November 6, 2018

RE: Peer Review of Additional Information, Proposed Upland Landfill, Campbell River, BC

Figure 1. Water-level contours prepared by GHD, September 17, 2018 (from Figure 5.1, GD Response Letter Task 7).

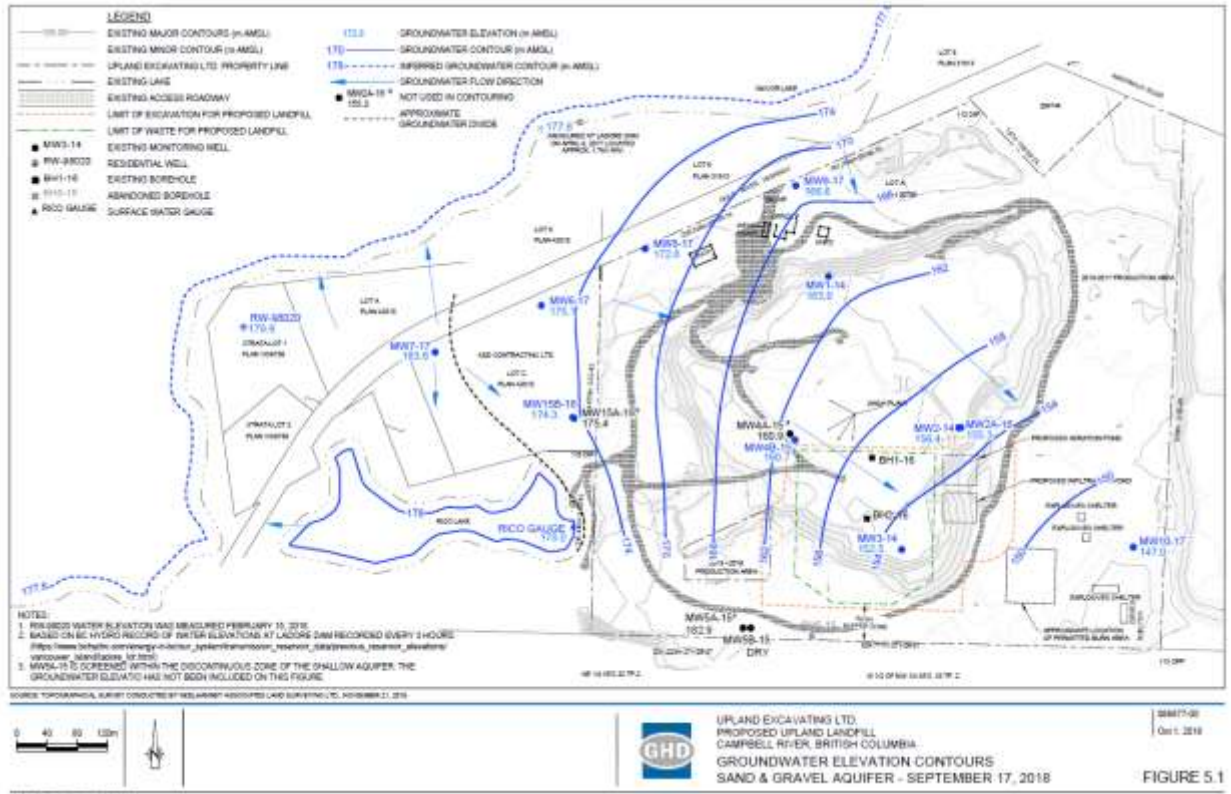
The presence of a perched zone or deeper water table at MW5A-15 has no influence on groundwater flow beneath the Site (refer to Figure 5.1 of GHD, reproduced above as Figure 1), or the potential to reverse the measured vertically upward hydraulic gradients from bedrock into the Sand and Gravel Aquifer.

Fractured bedrock is likely conveying a significant groundwater flux from Rico Lake to the east towards and beneath the Site. The groundwater contours presented on Figure 5.1 of GHD (reproduced as Figure 1 above), can be used to measure hydraulic gradients, which appear to have ranged from about 0.04 to 0.06 m/m in September 17, 2018. The gradients are significantly greater than the hydraulic gradient used by GHD in their analysis to estimate groundwater flux beneath the Site (0.03 m/m). The higher gradient in September 2018 indicates a greater groundwater flux on that date than estimated previously. Of relevance to the proposed landfill, greater measured gradients are indicative of larger groundwater fluxes beneath the proposed landfill which, in turn, indicate greater dilution of any mass loading from a liner leakage or failure scenario of the proposed landfill.

Figure 2. East-west stratigraphic cross section prepared by GHD (from Figure 2.10, additional information, HHCR Report).

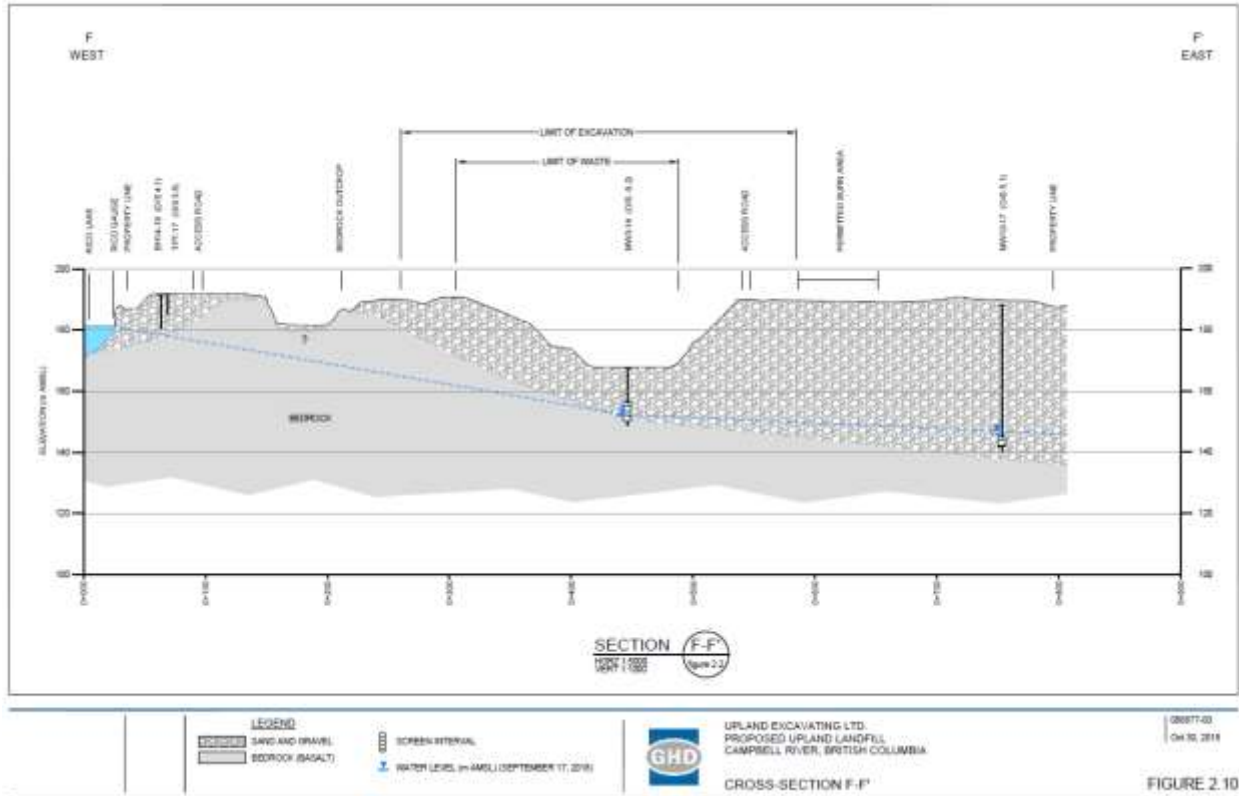
In their interpretation of Site geology, GHD states that the bedrock between Rico Lake and the Site “significantly restricts the movement of groundwater between these two features”, and makes reference to areas of competent versus fractured bedrock. Estimates of bedrock K were noted to be variable (i.e., MW15A-18, 8.3×10^{-3} cm/sec; MW14A-15, 2.2×10^{-2} cm/sec; and MW5A-15, 1.4×10^{-5} cm/sec).

In my view, GHD’s assessment understates the relevance of the fractured bedrock in conveying groundwater from Rico Lake to the Sand and Gravel Aquifer beneath the Site. Groundwater flow through the basalt occurs via secondary porosity features (i.e., open fractures), and the basalt bedrock across the Site is typically fractured (refer to Figure 3, below), as reported on all GHD borehole logs drilled into bedrock, and as I observed in rock cores from MW15A-18 and in bedrock outcrops during my Site visit.

Figure 3. A) Rock core from MW15A-18 showing a weathered horizontal fracture (light brown weathered surface), and an unweathered fracture that probably resulted from coring. B) Weathered sub-vertical fractures in core from MW15A-18.

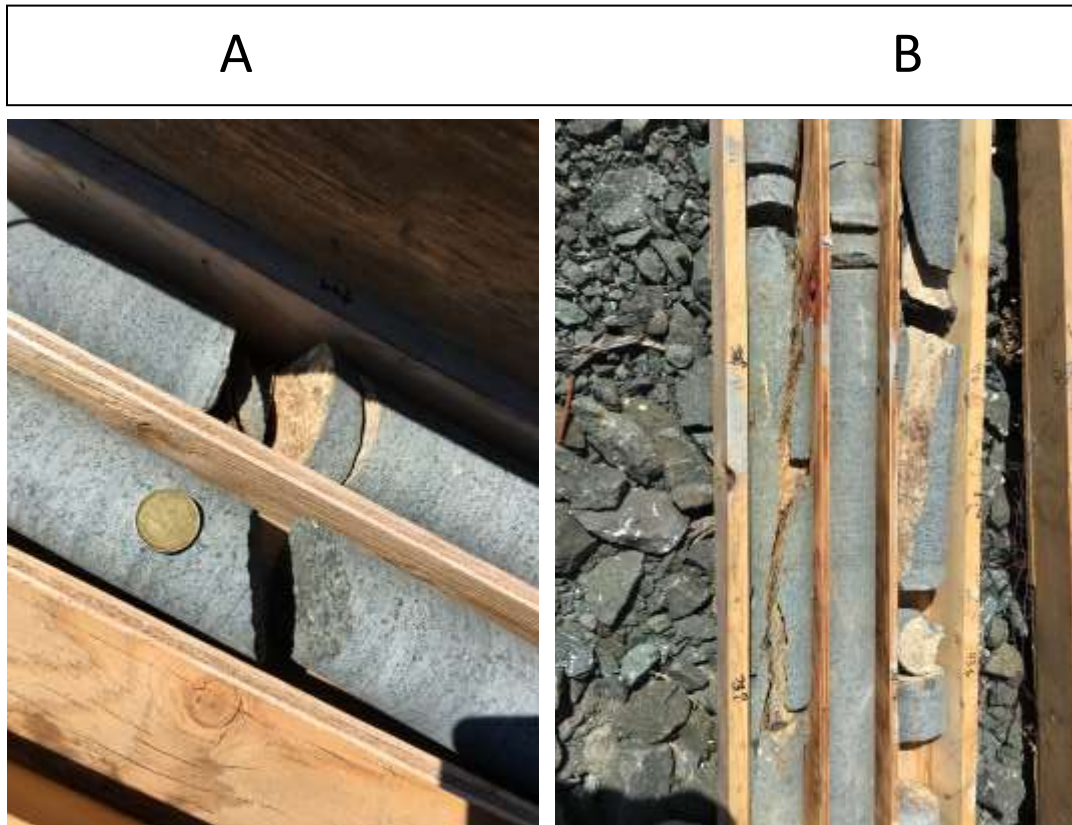
The hydraulic conductivity estimates for the bedrock, the recent groundwater elevation contour maps, and my observations all support the likelihood that the bedrock is a significant groundwater flow system at the Site. The frequency of fractures and groundwater contour maps indicate an interconnected fracture network, which in my view likely behaves as an equivalent porous medium at a volumetric scale of a few tens of cubic metres or less.
